THE MARYLAND-NATIONAL CAPITAL PARK AND PLANNING COMMISSION

**MEMORANDUM**

REVIEW TYPE: **Preliminary and Site Plan Review**  
CASE #: **1-05024 and 8-05017**  
PROJECT NAME: **Tong Subdivision, Lots 1-13, Parcel A-C**  
APPLYING FOR: Approval of 13 one-family detached units, including 1 existing dwelling unit, and 10 Transfer Development Rights (TDRs), and the waiver of the 2/3 minimum requirement for TDRs on 9.13 acres  
REVIEW BASIS: Div. 59-D-3 of Montgomery County Zoning Ordinance  
Chapter 50, Montgomery County Subdivision Regulations  
ZONE: RE-2/TDR 2 and RE-2/TDR 4  
LOCATION: Located north of Spartan Road approximately 175 feet west of the intersection of Snowberry Way  
MASTER PLAN: Olney Master Plan  
APPLICANT: Magruder/Reed @ Christie Estates, LLC  
FILING DATE: November 23, 2004  
HEARING DATE: February 17, 2005

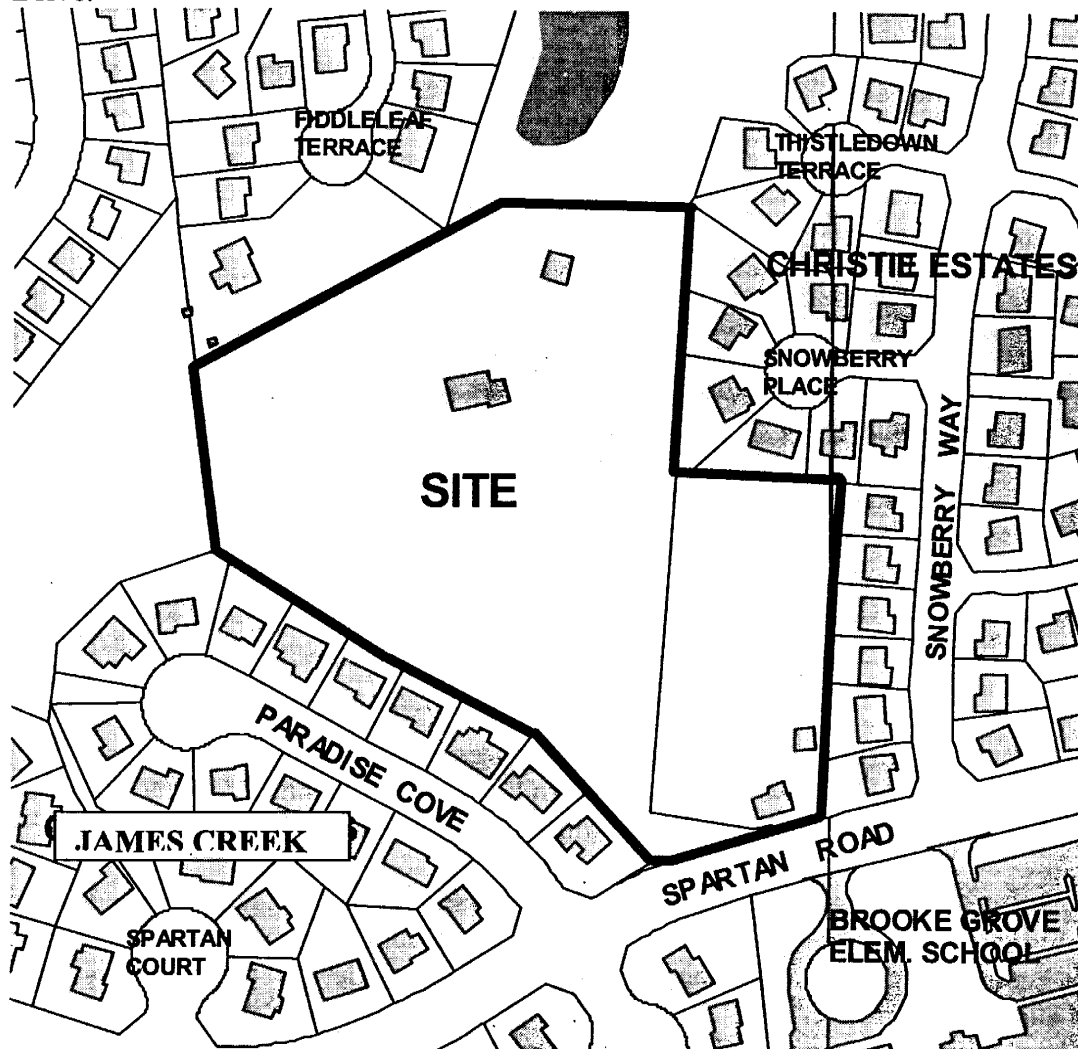
The Applicant has requested a waiver to change the functional classification of the proposed Street A from a secondary road to a reduced-width tertiary road. The street right-of-way would be reduced from 50 feet to 27.33 feet and the cul-de-sac bulb would be reduced from a diameter of 120 feet to 88 feet, 8 inches. The waiver also addresses the request to construct a sidewalk on only one side of the road and cul-de-sac. Granting of the waiver requires an environmental justification that would result in an overall design that is environmentally better and makes better use of the overall tract of land for the desired combination of land uses, consistent with Section 50-26(h)(2) of the Montgomery County Zoning Ordinance.

As noted in the previous discussion in this report, the environmental constraints of the site, proximity of the adjacent lots in the surrounding community, lot configuration, and location of the stormwater management facilities make a reduced width tertiary right-of-way more compatible with the community, practical and environmentally responsible given the site constraints.

Narrowed tertiary streets allow the development areas to be more compact and removed from the sensitive perimeter environmental areas. Staff is supportive of the waiver requests and has received no objections from the Montgomery Department of Public Works and Transportation.
